**PROBLEM:**

**CORRECTION:**

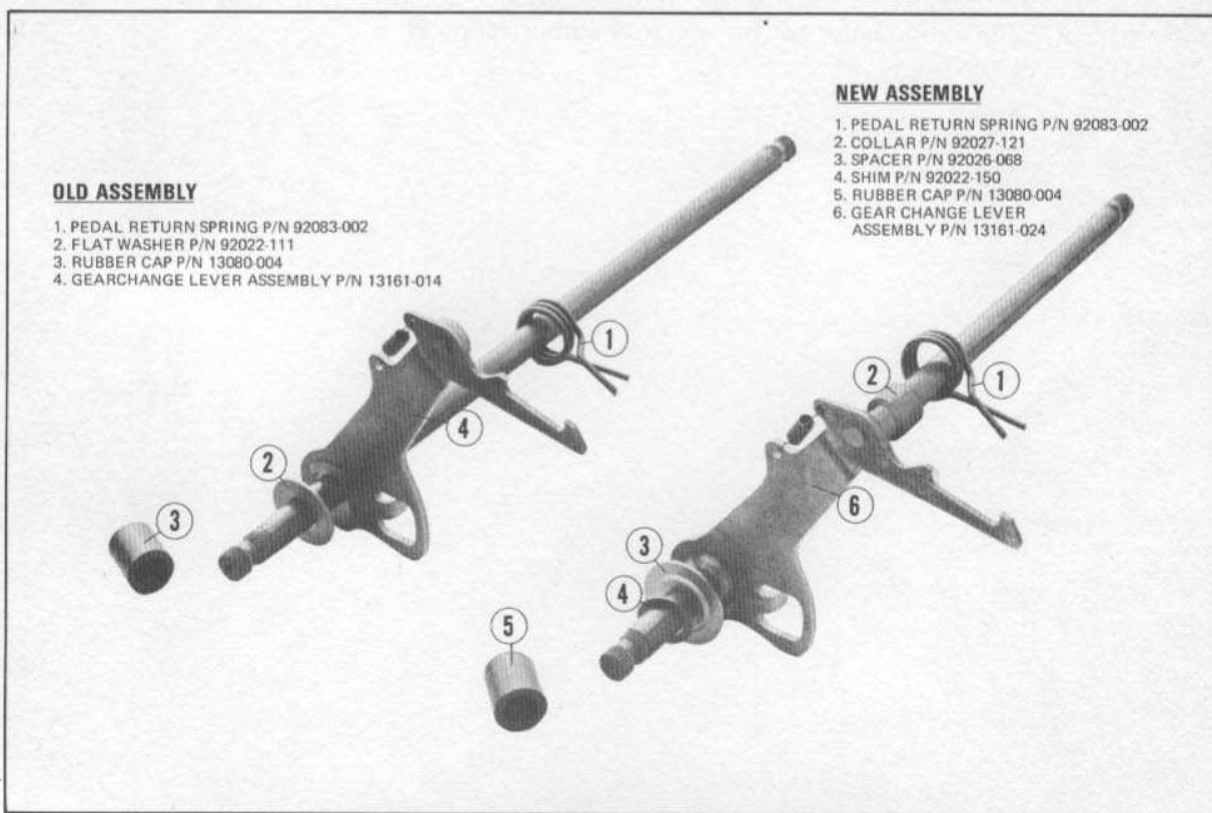
On the early H1 models, the gear change lever assembly consisted of a toothed lever staked to a rod. This construction sometimes loosened up, causing sloppiness in shift lever movement. This contributed to missed shifts, and sometimes led to transmission damage.

An additional point of confusion comes from a variation in the assembly as pictured in the parts manuals for H1B and H1D.

To remedy this problem, a new gear change lever assembly was designed for the H1 and H2. The new unit is welded, rather than staked, and includes a collar inside the pedal return spring, a spacer, and a shim outside the spacer.

The correct assembly of the new gear change lever assembly is pictured on the right below. The outside shim (P/N 92022-150) does not yet appear in any parts books but it is included in the position shown on current production machines of both H1 and H2. The new assembly is used on all H1's after Engine No. KAE 43902 and on all H2's, and is interchangeable with older parts.
